2.3 State, Regional, and Local Agencies

2 COMMENTS AND RESPONSES

Subject: Draft Environmental Impact Report (EIR) for Corte Madera Creek Flood Risk Management Project, Phase 1, Marin County

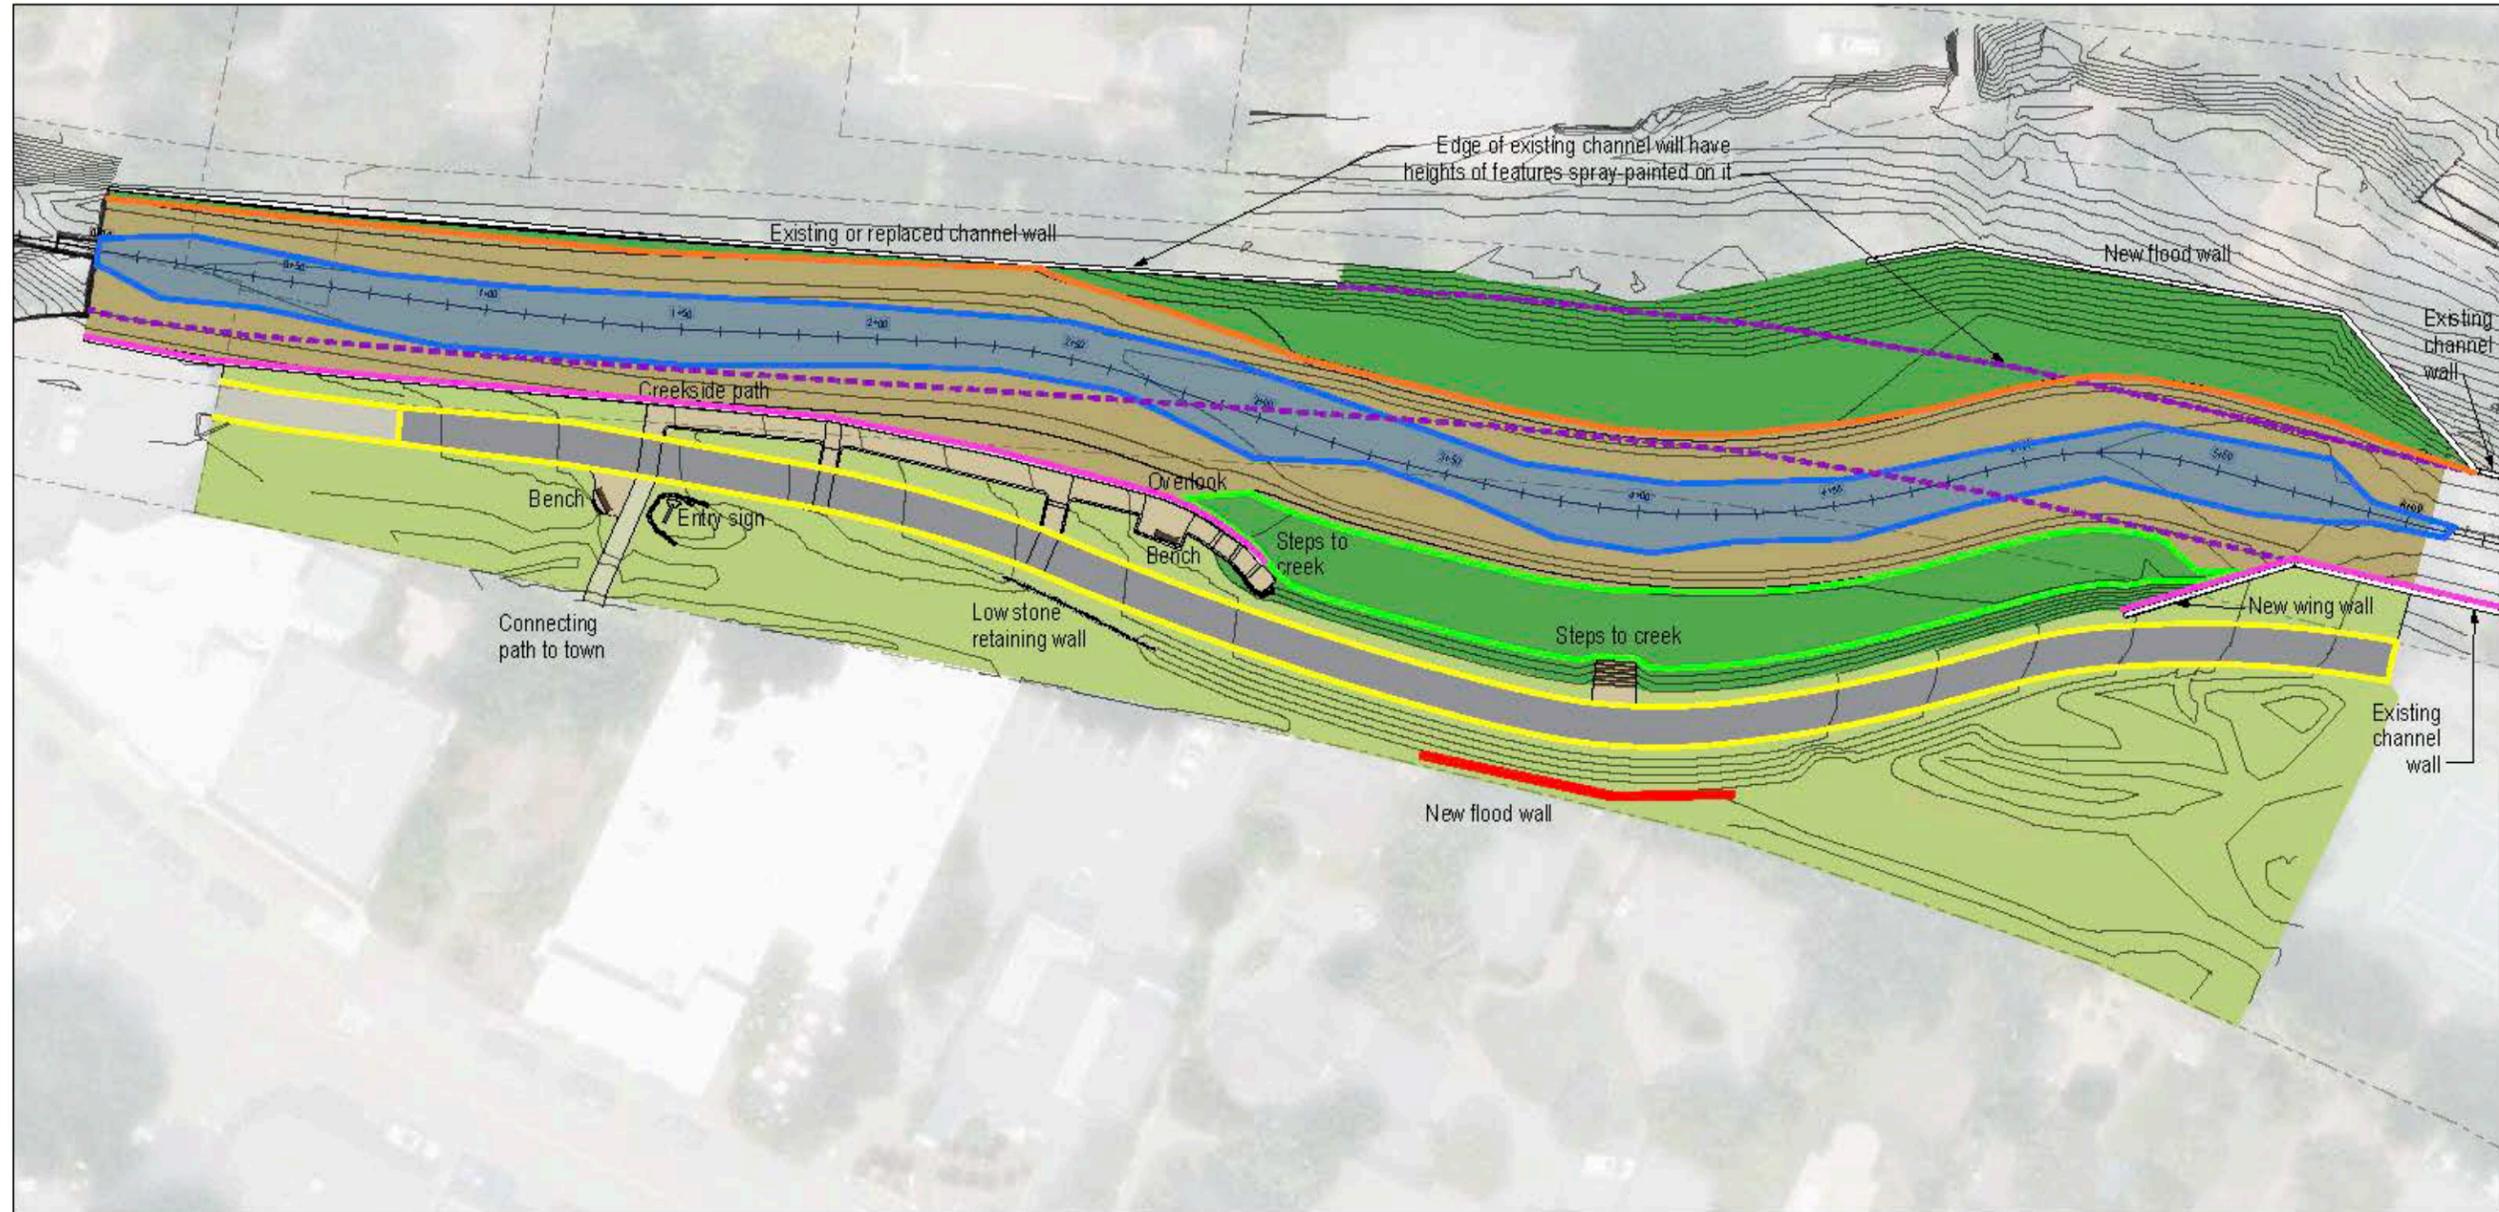
- A5-10 The commenter states that a maintenance memorandum of understanding (MOU) for the project components in Frederick Allen Park that overlap both District and Town of Ross properties should be described in Section 2.7.2 Maintenance.

Section 2.7.2 of the Draft EIR (page 2-42) has been revised as follows to include a discussion of the maintenance agreement between the Town of Ross and the District for project elements in Frederick Allen Park.
